# SERVICE BULLETIN

SERVICE BULLETIN NO: 30-001

## ICE AND RAIN PROTECTION - PITOT-STATIC AND AOA ANTI-ICE SYSTEM STATIC-PORT HEATER WIRES - INSPECTION

Inspection  
Figure 1

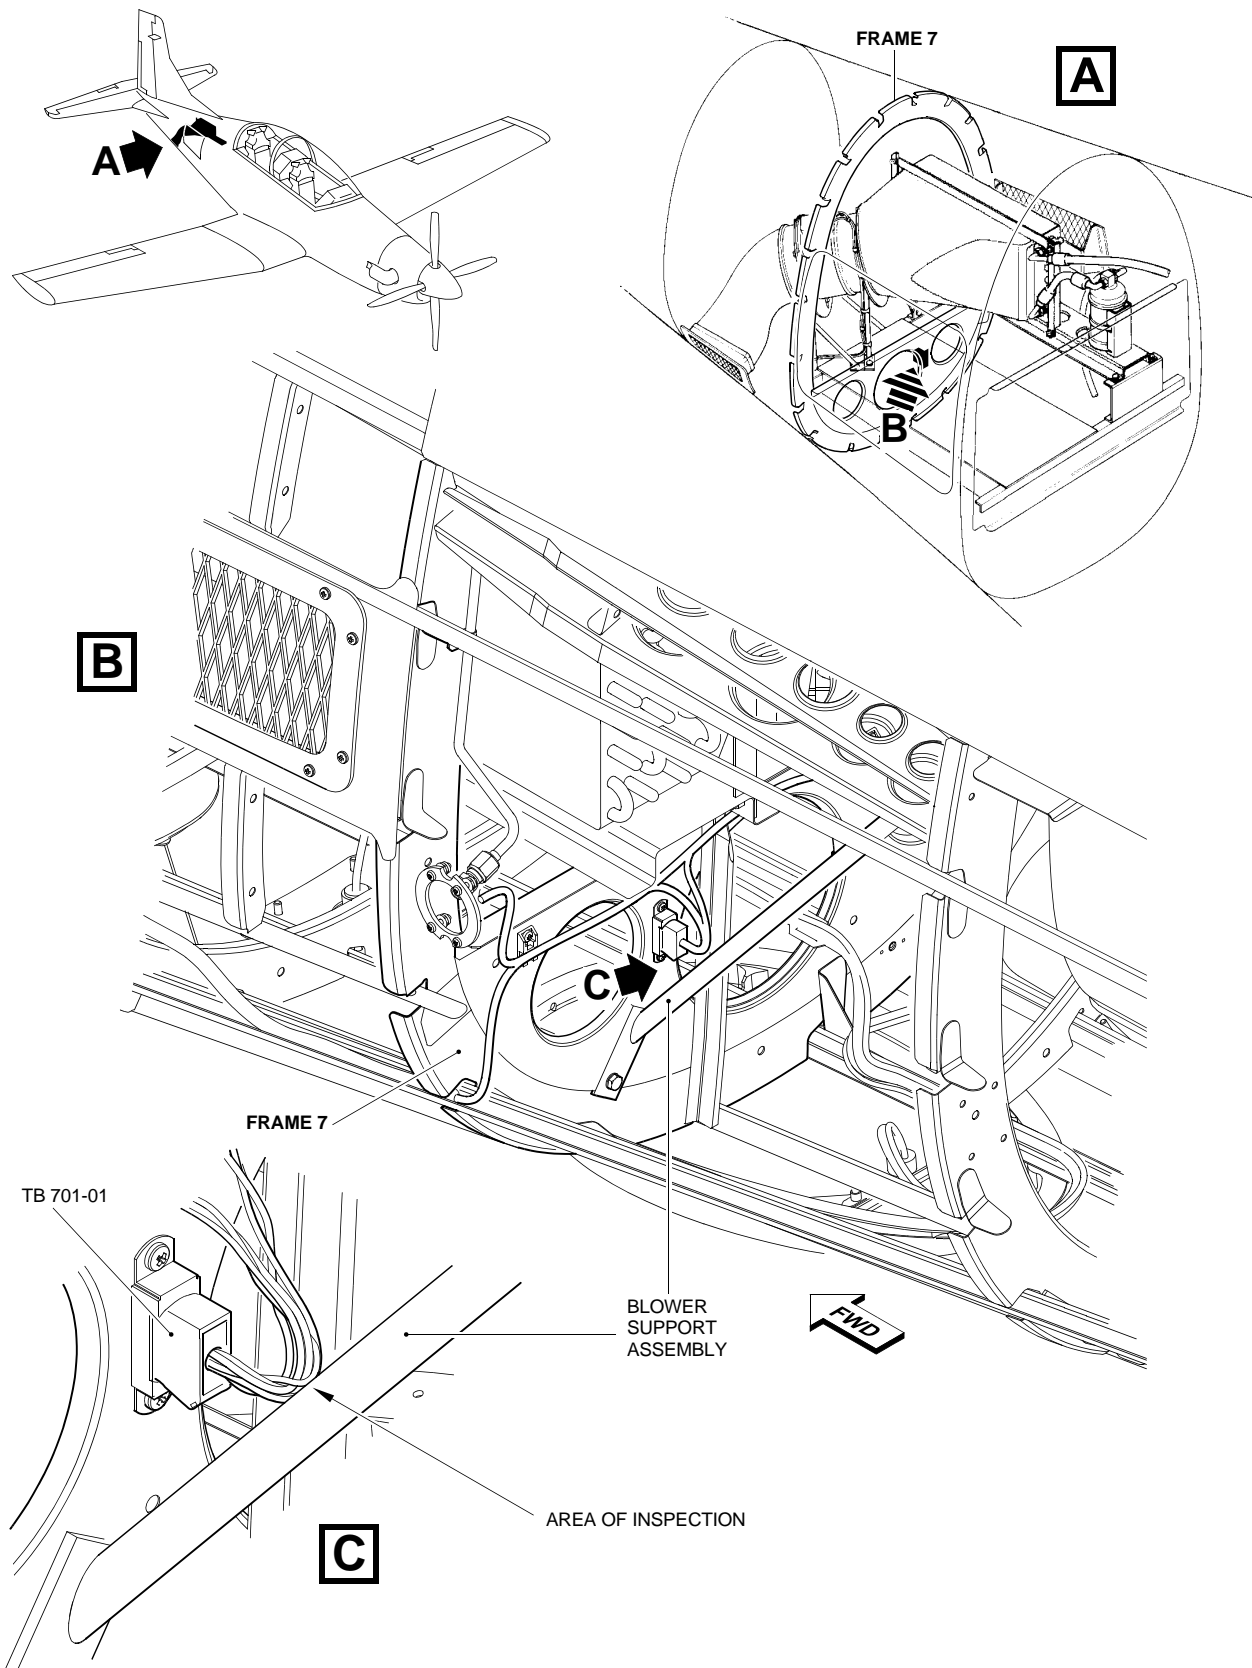
Chafing of electrical wires against a support strut for the condenser fan.

**B. Inspection (Ref. Fig. 1)**

- (1) Examine the wires connected to TB701-01 to see if they can touch the support-strut for the condenser blower motor:
- (a) If the wires do not touch the strut, and you cannot move them to make them touch, no further action is necessary. Continue the procedure at Para. C. Test.

- (b) If the wires touch the strut, or if you can move them to make them touch:
    - (i) Use a bright light source and X10 magnifier to examine the wires for chafing or burning.

- (ii) If you find signs of melting, burning or the insulation is worn so that you can see the metal wire inside, you must replace the wire(s). Obey the safety precautions given in AMM 24-00-00, Page Block 201.

- (iii) Apply glass-fiber tape (Material No. P09-020) around the support-strut where the wires can touch.
    - (iv) If possible, attach the wires to the support-strut with cable ties (Material No. P09-008) to prevent movement. Do not do this if it puts strain on the wires.
